World Forum for Harmonization of Vehicle Regulations**Working Party on Brakes and Running Gear****Seventy-sixth session**

Motorcycle braking – Regulation No. 78**Proposal for amendments to Regulation No. 78 (Uniform provisions concerning the approval of vehicles of categories L₁, L₂, L₃, L₄ and L₅ with regard to braking)****Submitted by the expert from the International Motorcycles Manufacturers Association***

The text reproduced below was prepared by the expert from the International Motorcycles Manufacturer Association (IMMA) to introduce amendments clarifying the current text on the use of Combined Braking Systems (CBS). The modifications to the current text of the Regulation are marked in bold for new or strikethrough for deleted characters.

CBS Architecture B

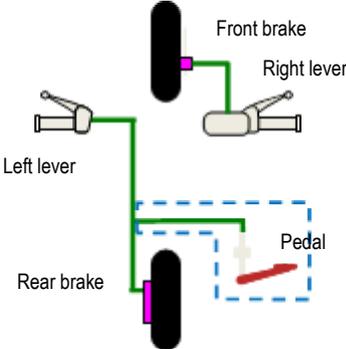
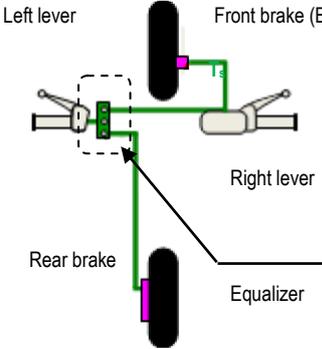
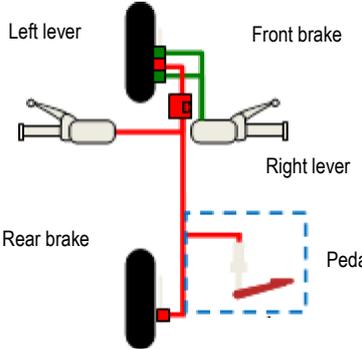
1. The current provision in UN Regulation No. 78 (para. 5.1.9), requiring that "two separate brake systems may only share a common brake if a failure in one system does not affect the performance of the other", limits the application of Combined Brake Systems (CBS).
2. Not all CBS architectures can meet this requirement although they will outperform conventional brake systems.
3. Not all CBS architectures were however considered at the time the original CBS requirements were drafted (in the 1980s) and it is therefore understood that GRRF did not intentionally exclude such systems by introducing this requirement.
4. Architecture B is an example of a CBS that shares a transmission (T_s) and a brake (B_s).

5. While a failure in e.g. the "front system" (F_A) may affect the performance of the CBS, the rear system (operated by the left lever) will continue to be operational.

6. In order to ensure that, in case of a failure in one system, the performance of the other system still equals that of a conventional system, it is proposed to allow that two separate brake systems share a brake and/or a transmission, provided that the other system meets the single brake system performance requirements in case of a failure of such shared component(s). To that end, a failure test is proposed for CBS brake systems of Architecture B. IMMA is of the opinion that such a failure test requirement should ensure the acceptance of such a CBS in terms of demonstrated robustness and guaranteed minimum braking performance.

"5.1.9 In cases where two separate service brake systems are installed, the systems may share a common brake, ~~if a failure in one system does not affect the performance of the other~~ a common transmission, or both if the requirements of Annex 3, paragraph 12 are met."

(a) Alter the brake system to produce a hydraulic hose or mechanical cable type failure causing a complete loss of braking in the portion of the system which is shared;

(b) Perform the dry stop test specified in section 4.3. in laden condition. Other conditions to be observed are 4.3.1. (c) and 4.3.2. (a), (b), (d), (e) and (f). Instead of the provisions in section 4.3.2. (c), only apply the control for the service brake system not affected by the simulated failure.
